Access Compliance Report

Public Rights-of-Way

(Curb Ramps)

Intersection ID: 20047	Main Street: SHARON_RD	Cross Street: MORRISON_BV	Location: S
ADA ID: C20A08F8EFAD	Ramp Type: PerpDiag	Initial Pass/Fail: Fail	Overall Compliance: No
Codes/Mitigation Info/Possible Solution		Field Measurements/Component Compliance	
Severity Score: 12.5

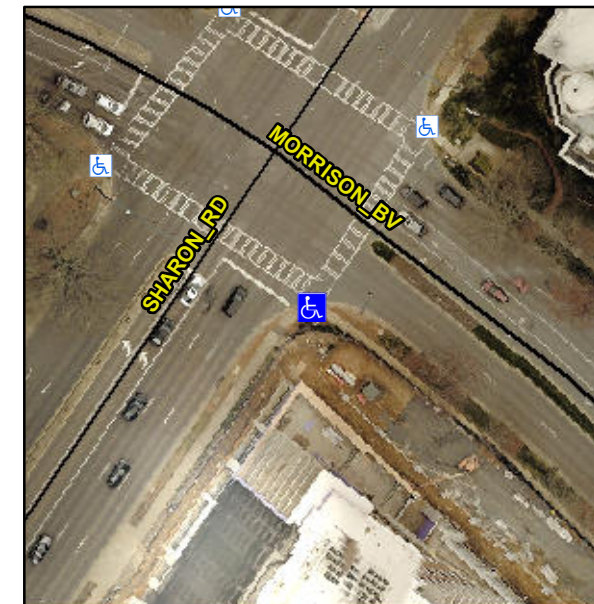
Compliance	Description	Data	Compliance	Description	Data
N/A	Ramp Length (in)	59.0	No	Ramp Slope (%)	9.0
Yes	Ramp Width (in)	58.5	Yes	Ramp XSlope (%)	0.2
N/A	Flare Type LT	N/A	N/A	Flare Type RT	N/A
N/A	Flare Slope LT (%)	N/A	N/A	Flare Slope RT (%)	N/A
N/A	Flare Traversable LT?	N/A	N/A	Flare Traversable RT?	N/A
N/A	Landing Length (in)	N/A	N/A	DWS Provided?	N/A
N/A	Landing Width (in)	N/A	N/A	DWS Contrast?	N/A
N/A	Landing Slope (%)	N/A	N/A	DWS Length (in)	N/A
N/A	Landing X Slope (%)	N/A	N/A	DWS Full Width?	N/A
N/A	Landing Curb? (Y/N)	N/A	N/A	DWS Offset (in)	N/A
N/A	Shared Landing?	N/A			
N/A	Gutter Ponding?	N/A	N/A	Gutter Slope (%)	N/A
N/A	Gutter Lip Ht (in)	N/A	N/A	Gutter X Slope (%)	N/A
N/A	Painted X Walk1?	Yes	N/A	Painted X Walk2?	Yes
	X Walk 1 Direction	To NE		X Walk 2 Direction	To NW
N/A	X Walk 1 Width (in)	106.0	N/A	X Walk 2 Width (in)	115.0
	X Walk 1 Slope (%)	0.0		X Walk 2 Slope (%)	4.0
	X Walk 1 X Slope (%)	3.8		X Walk 2 X Slope (%)	0.4

N/A	Ramp inside XWalk1?	Yes	N/A	Ramp inside XWalk2?	No
	Road Slope (%)	2.8	N/A	Clear Space?	N/A
	Road X Slope (%)	1.0	N/A	Clear Space to XWalk (in)	N/A
N/A	Any Obstructions?	N/A	N/A	Storm Grate/Utility Hazard?	N/A
	Obstruction Type			Storm Grate/Utility Type	
		N/A			N/A
		Yes		Surface Condition? (G/P)	Good

Remove & Replace Curb Ramp With Two New Directional Ramps or Equivalent. Restripe Crosswalk.
